**BROADWAY CHINATOWN
STREETSCAPE IMPROVEMENTS**

**TRAFFIC SIGNAL PLAN
BROADWAY, GRANT AND COLUMBUS**

CONTRACT NO. 1075J
DRAWING NO. E-3.0
FILE NO. 102,161
REV. NO. 1

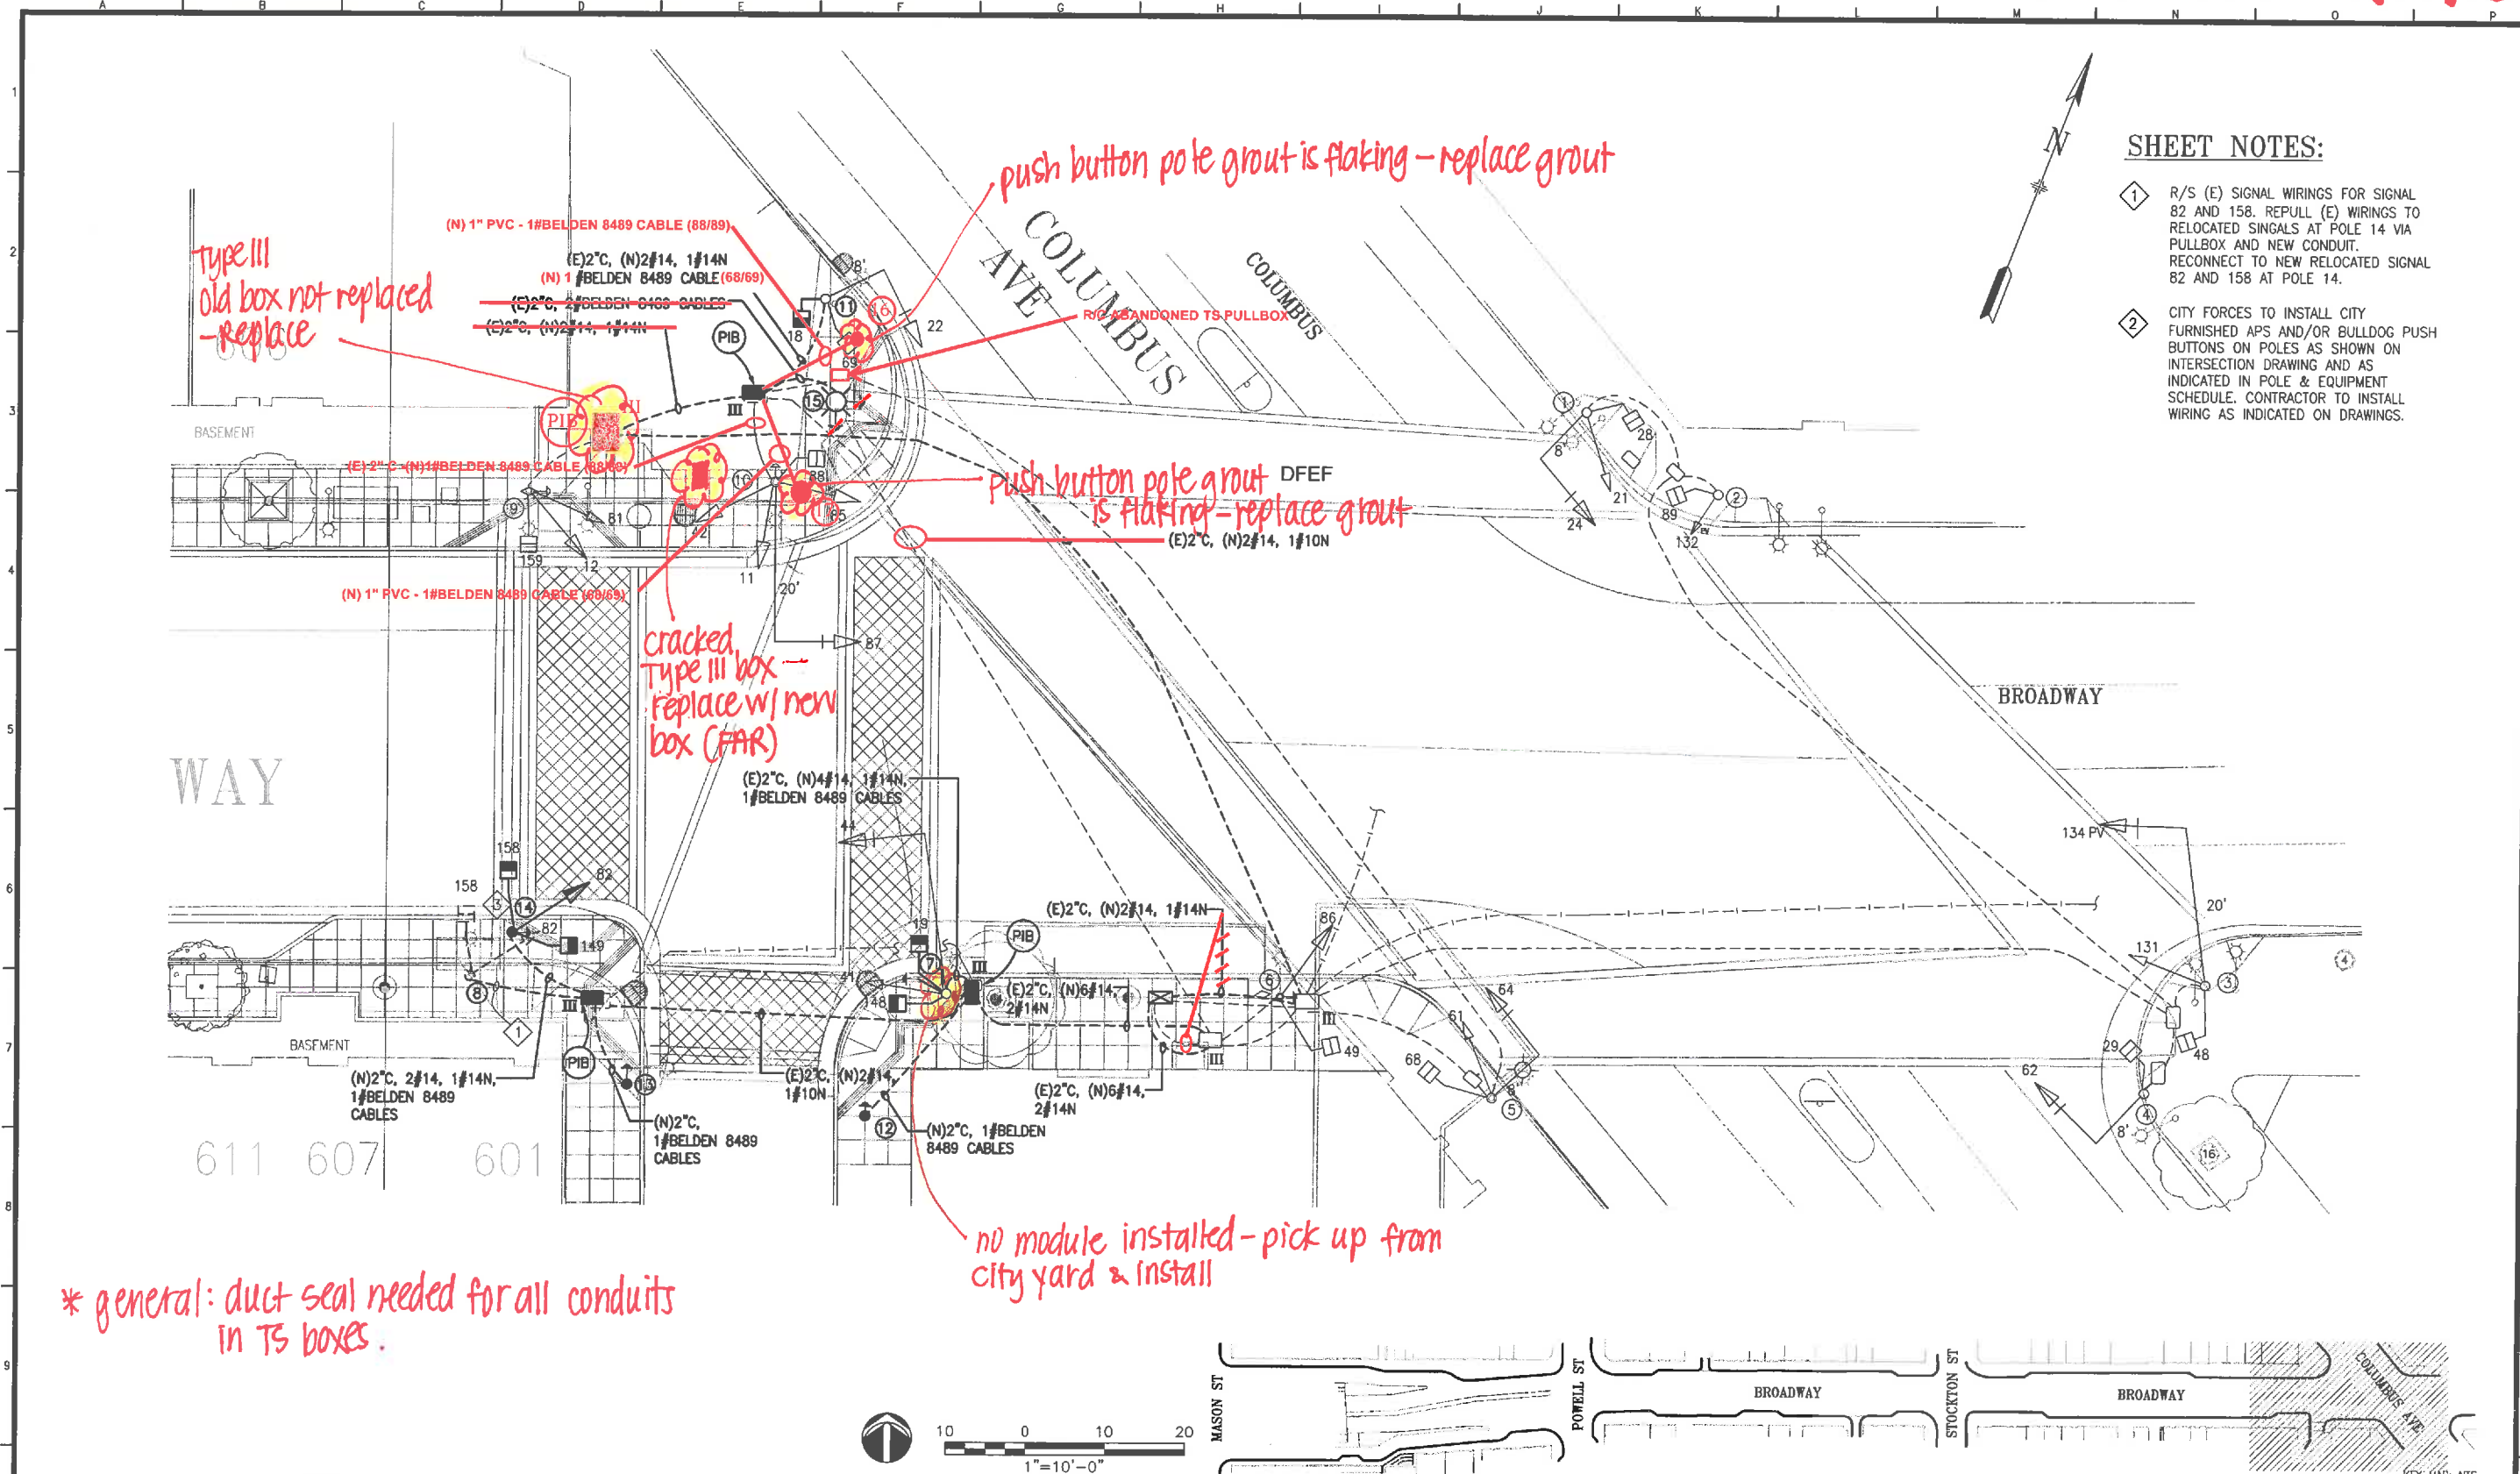
* general: duct seal needed for all conduits in TS boxes.
